SEQUOYAH NUCLEAR PLANT (SQN) UNITS 1 AND 2 - NRC INSPECTION REPORT NOS. 50-327,
50-328/88-12 - UNRESOLVED ITEM (URI) 88-12-04

The referenced letter provided NRC with TVA's response to URI 88-12-04. This
URI addressed NRC's concern with the double differentiation technique used to
generate the containment design basis accident spectra.

SUPPLEMENTAL INFORMATION ON UNRESOLVED ITEM (URI) 88-12-04

FIGURE 1

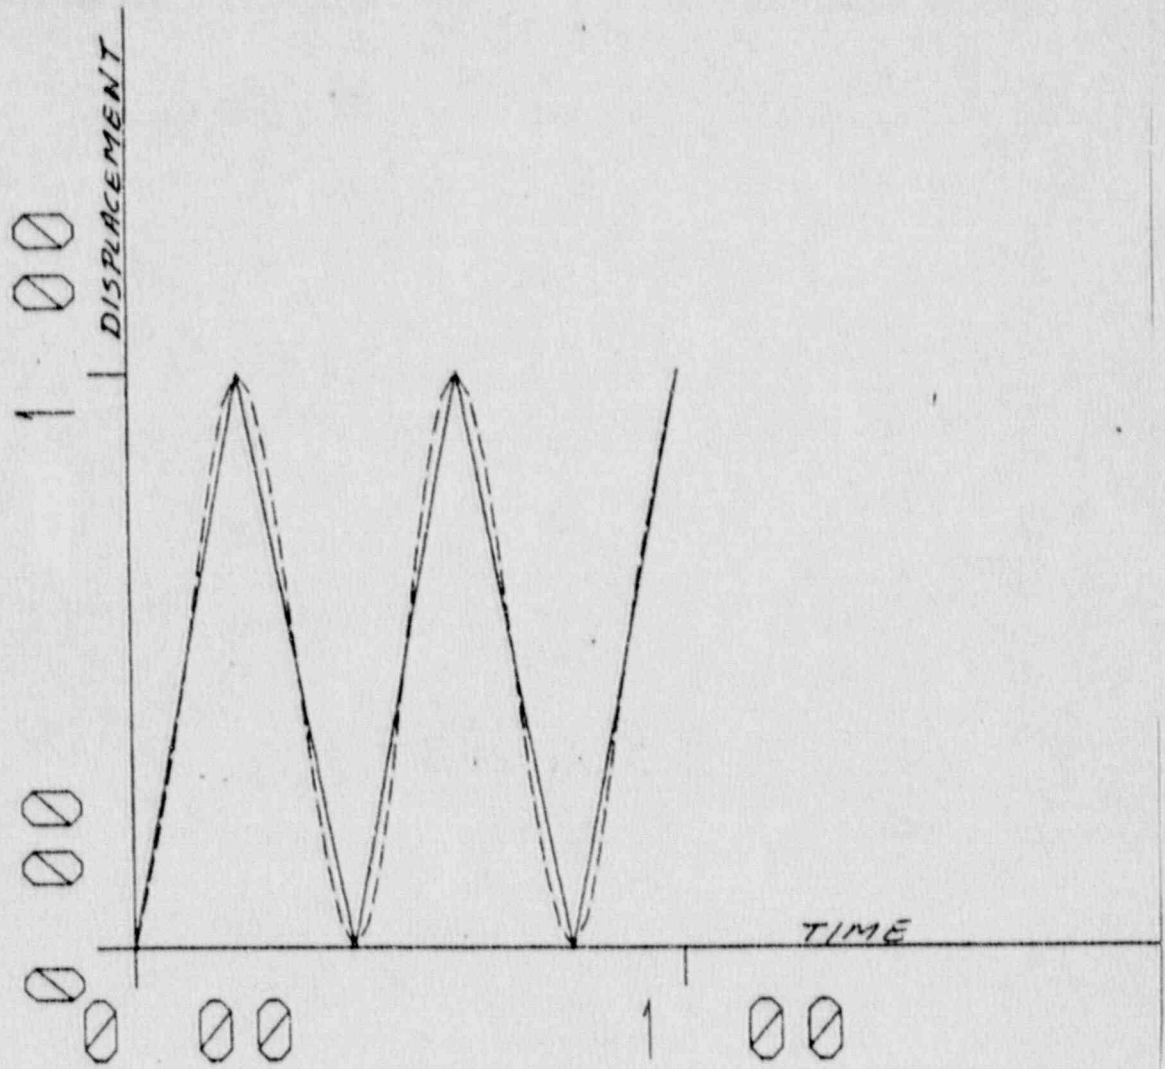
1. Provide the theoretical basis for the algorithm used in the SUPRPOS computer code to double differentiate the displacement-time histories calculated by the SUPERSHELL computer program.
2. Provide a statement concerning the occurrence of spectra peaks beyond 10 Hertz in the original DBA spectra after reviewing all available spectra at Elevation 763.58.
3. Provide an explanation of how vertical stiffeners were incorporated into the axisymmetric model used in the DBA analysis.
4. Provide a quantitative assessment of the steel containment vessel (SCV) response beyond 0.90 second.

Computer generated cubic spline displacement curve is plotted against input displacement data (FIGURE 1). Displacement and acceleration time histories are tabulated in TABLE 2. Specific time points are compared to hand calculations using the displacement and acceleration equations with the cubic spline coefficients tabulated on TABLE 2.

Figures B.1 to B.3 (attached) are the source of the data in the above table and are provided as visual aids.

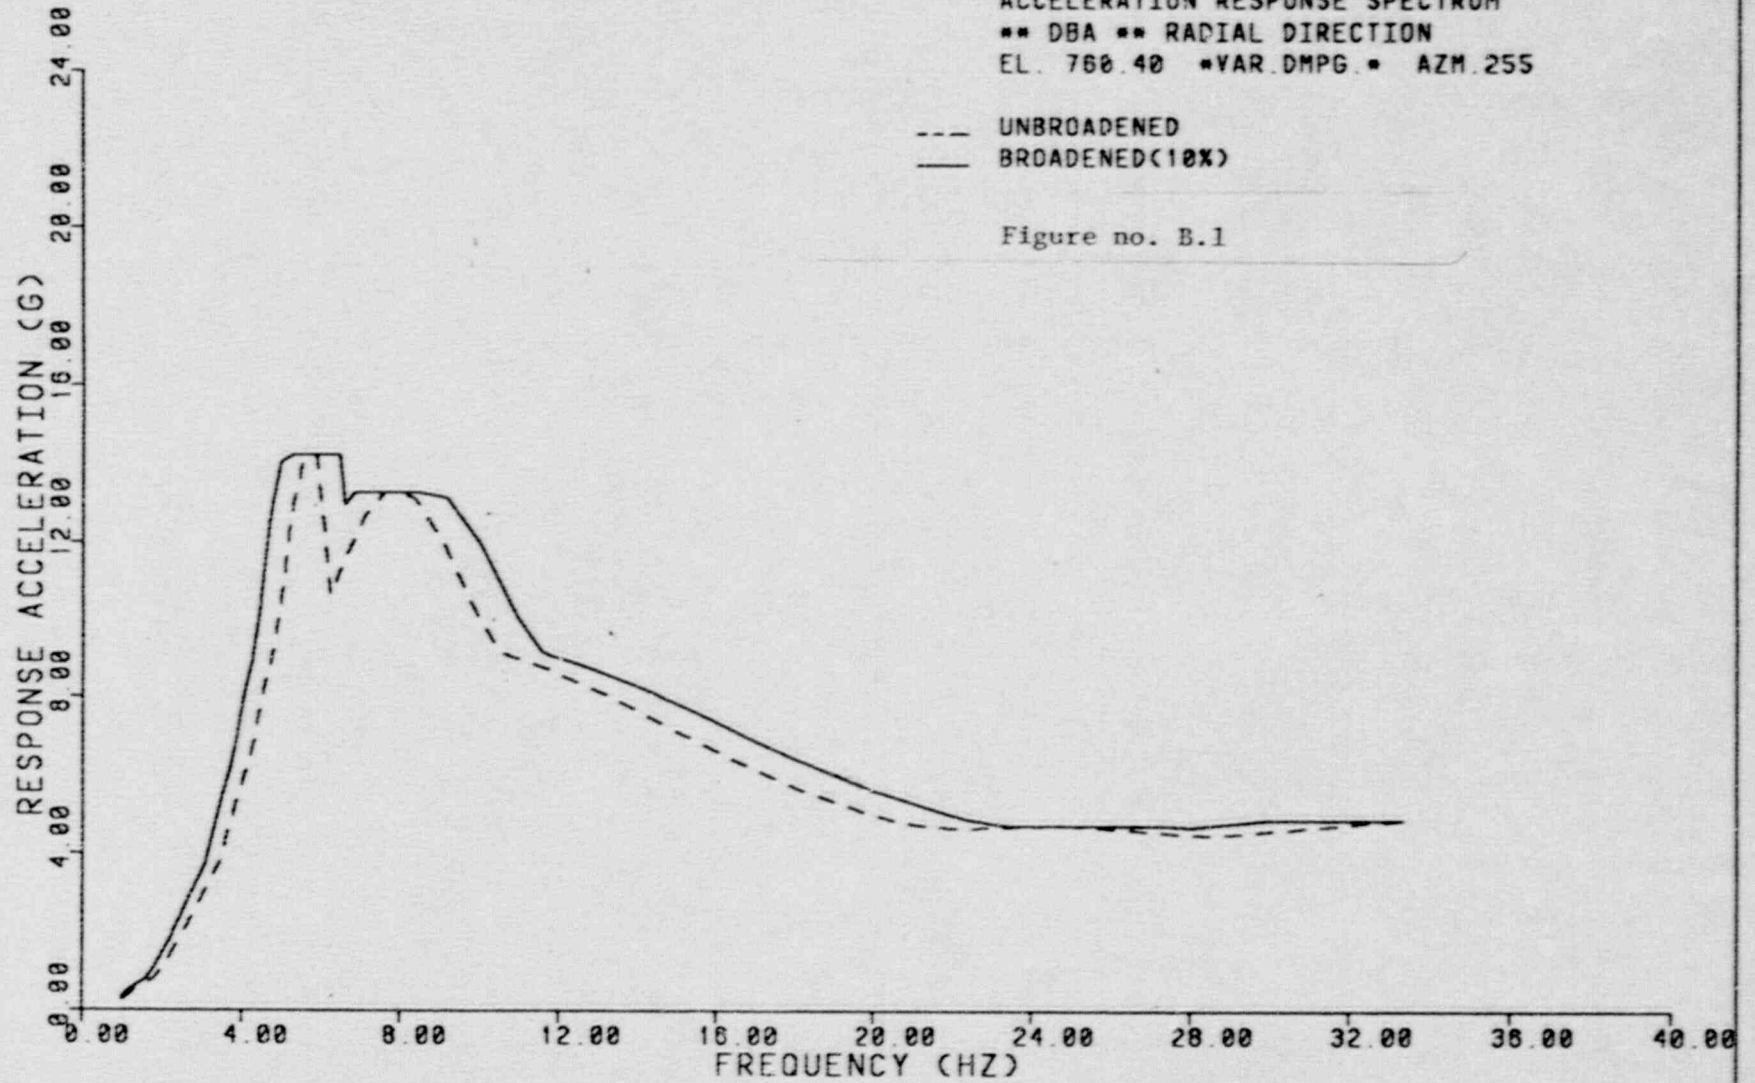
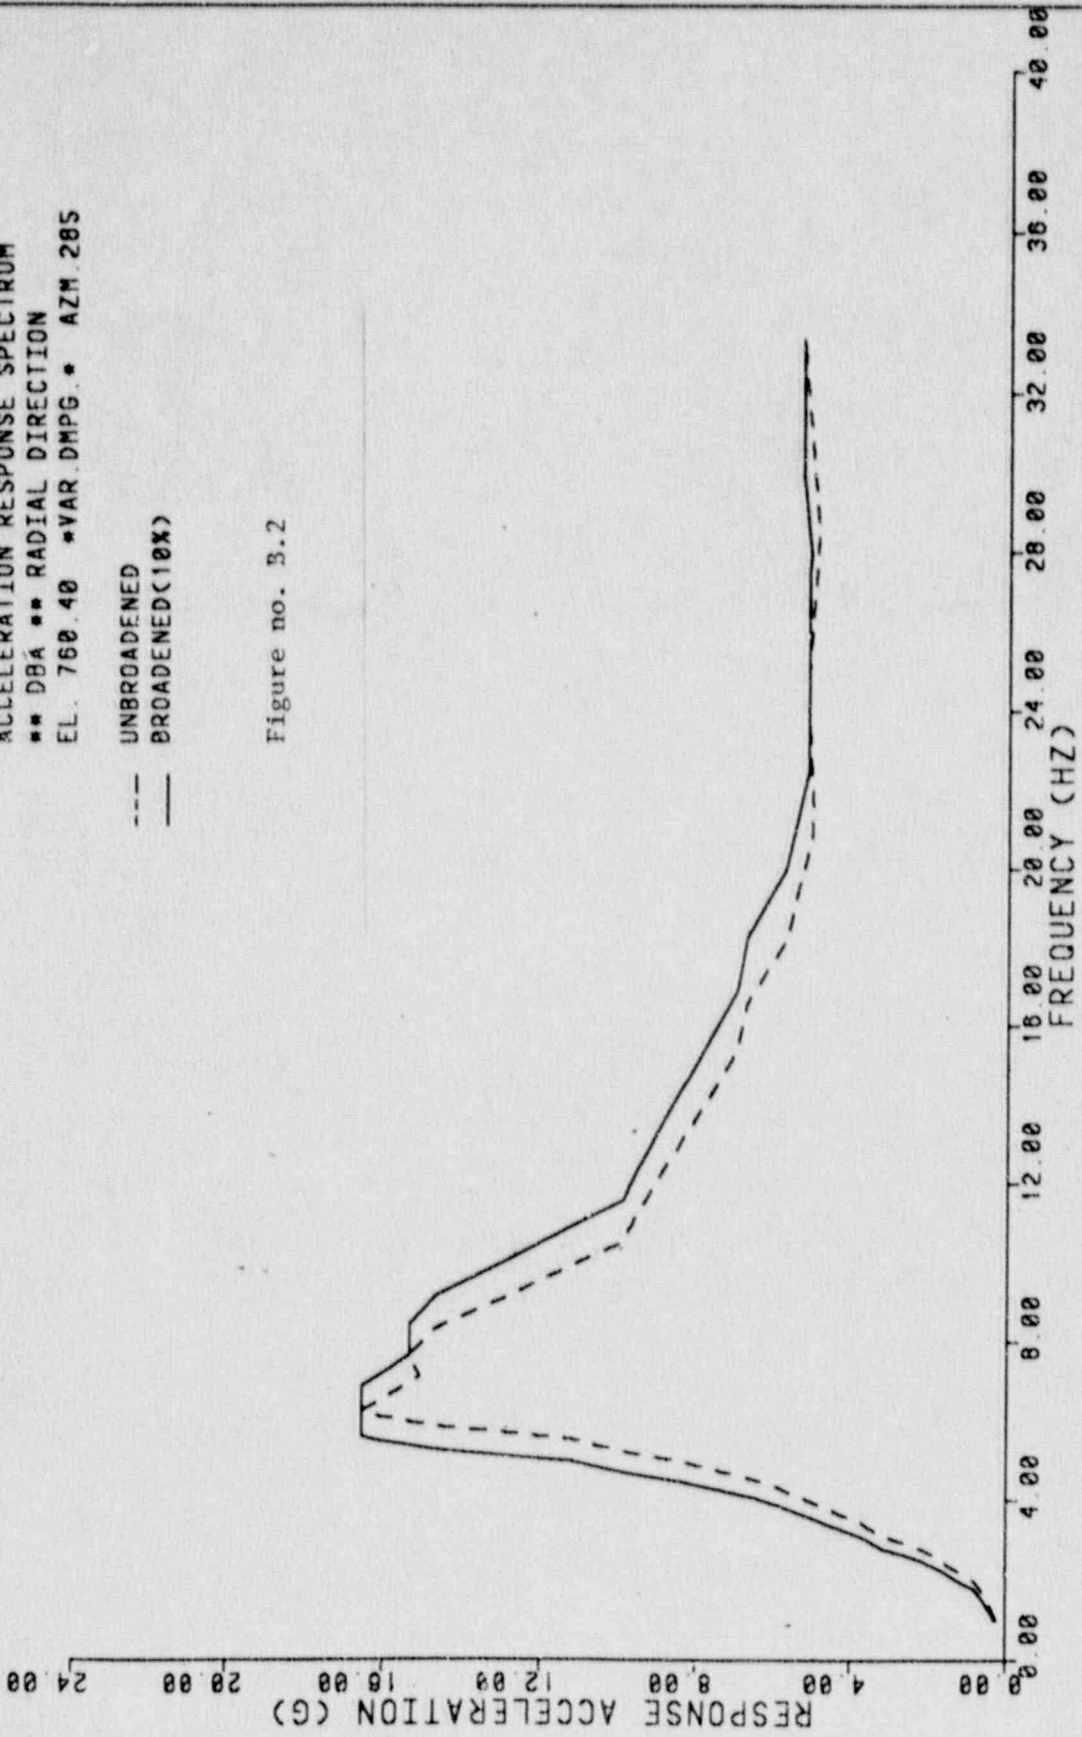
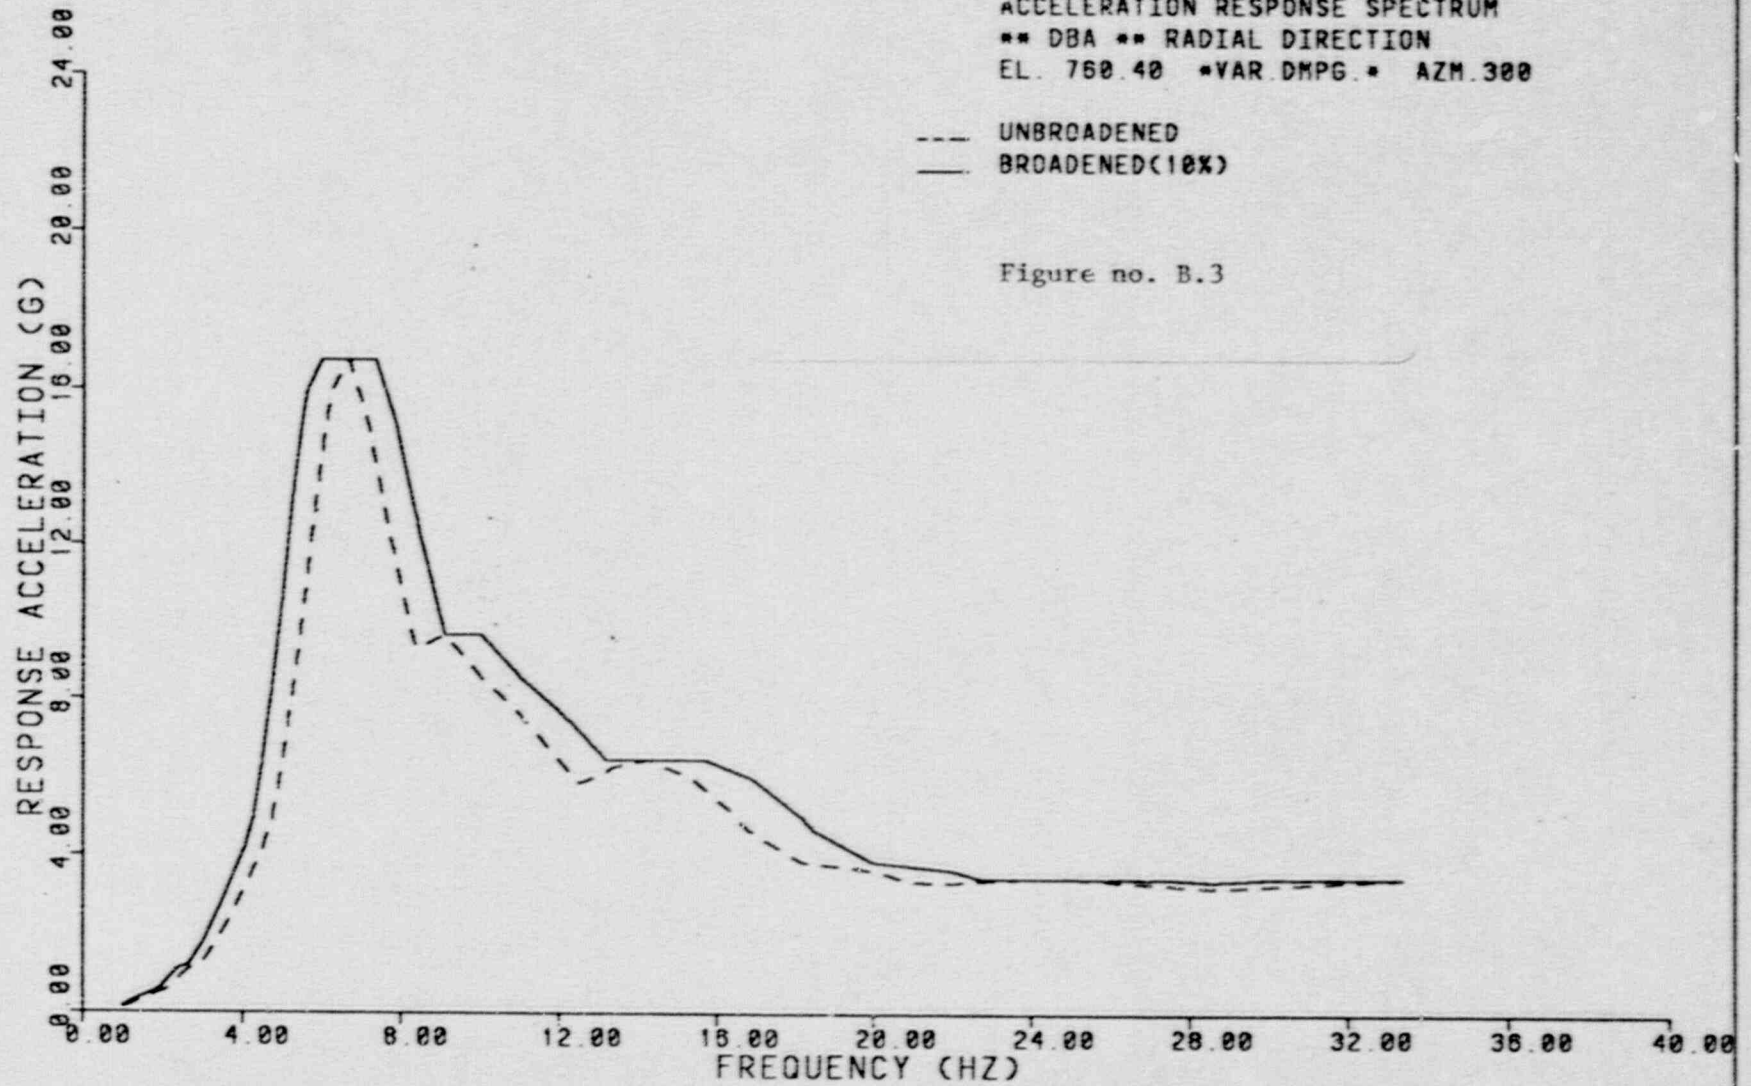
1. Item 1 will include the completion of a sample problem suggested by NRC, defining how the computer code SUPRPOS double differentiates a function.
2. Item 2 will provide three DBA plots available at Elevation 763.58 demonstrating the peaks beyond 10 Hertz. It will also provide the comparison table of peaks that was previously submitted to NRC.
3. Item 3 will define how Young's modulus was increased to incorporate the vertical stiffener effects.

A review of the original DBA dynamic analysis results (CEB report 86-20-C R0) for the Steel Containment Vessel elevation 760.4 (the elevation with available spectra closest to elevation 763.58) and all available plots of the above report has shown that no primary peaks occur above 10 Hertz. Although there is a secondary peak at approximately 14.5 Hertz, the magnitude of this peak is approximately 2.6 times less than the magnitude of the primary peak. The following table compares the magnitude of the primary peak, the secondary peak, and the ZPA of radial spectra at this elevation.

* Although these spectra (envelop of six hot leg breaks) show no secondary peak at 14.5 Hertz, the accelerations at this frequency are greater than the 6.5g at azimuth 300 degrees.

Figure No. D.6

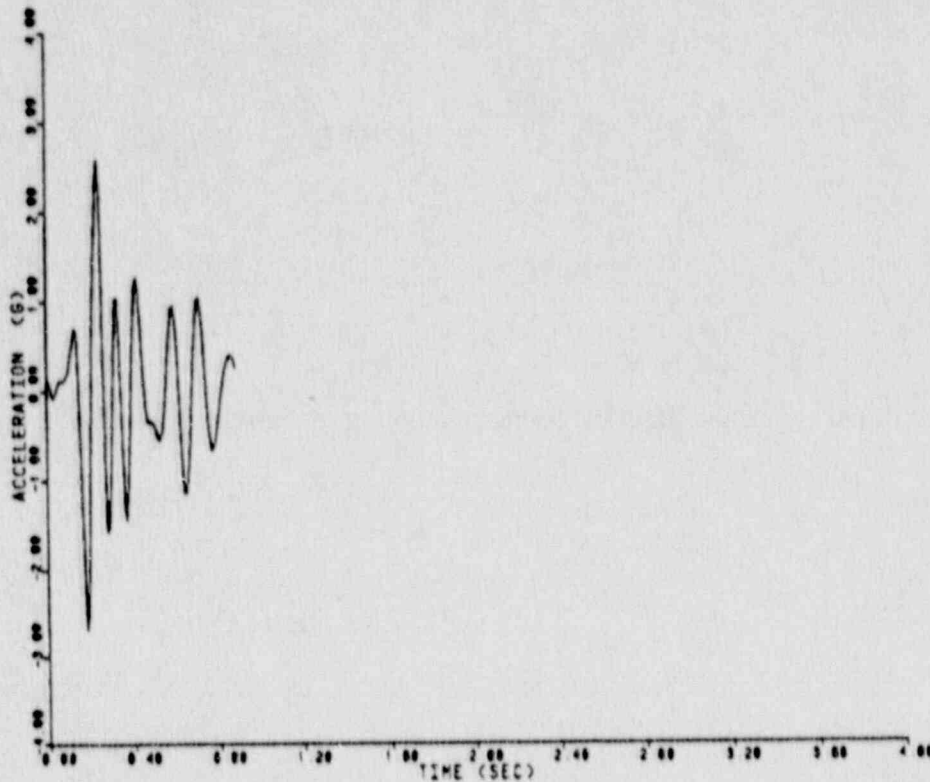
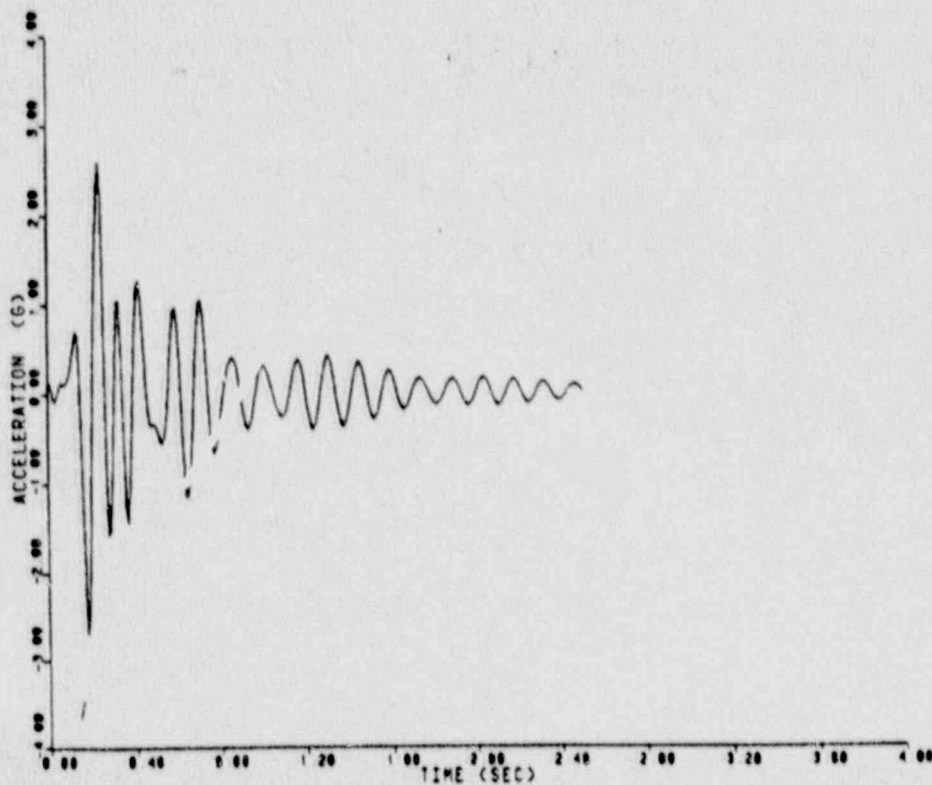
4. Item 4 will provide the calculation that has been developed to demonstrate effects on DBA spectra beyond 0.9 second to include a digitized comparison of the acceleration response spectrum (ARS) curves.

Figure D.6 is a comparison at Elevation 763.50 and 0 degrees Fahrenheit azimuth of the SCV acceleration response versus time for an analysis with a duration of 0.90 seconds and an analysis with a duration of 2.5 seconds (although the pressure-time input was 3.0 seconds, 2.5 seconds was used in the analysis). As shown, the two curves are identical for a 0.9 second duration. The curve for 2.5 seconds duration shows a decrease in amplitude from 0.9 to 2.5 seconds. Figure D.7 is a comparison of acceleration response spectra generated from the two time histories of figure D.6. Table D.1 is a digitized form of the curves of Figure D.6. The data of this table show that the two curves are essentially identical and indicate that the times of occurrence of the spectral values are less than 0.90 seconds. The calculation (SCG-2S-89-143) that is the basis of all comparisons is attached.

The comparison of the results from the two analyses show that the acceleration time history records are identical in the 0.0 to 0.90 seconds range and that between 0.90 second and 2.50 seconds the record decreases in amplitude. Additionally, the comparison of acceleration response spectra shows that the dynamic response of the steel containment vessel is unchanged by the addition of pressure data beyond 0.90 seconds.
